Mitsubishi Electric AC Servo System

No.24-11E

Change in Appearance of Analog Monitor Connectors and Monitor Cable Connectors for General-Purpose AC Servo Amplifiers

Servo amplifier	Analog monitor connector (CN6)		
·	Before change	After change	
A con-	Pitch: 2 mm	Pitch: 2 mm

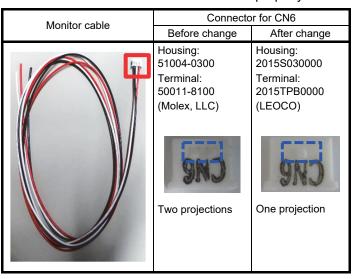
The parts of the analog monitor connectors (CN6) and the monitor cable connectors for servo amplifiers, shown in the red frame in the figure below, will be changed. The existing servo amplifiers and monitor cables will fit into the changed analog monitor connectors and monitor cable connectors properly.
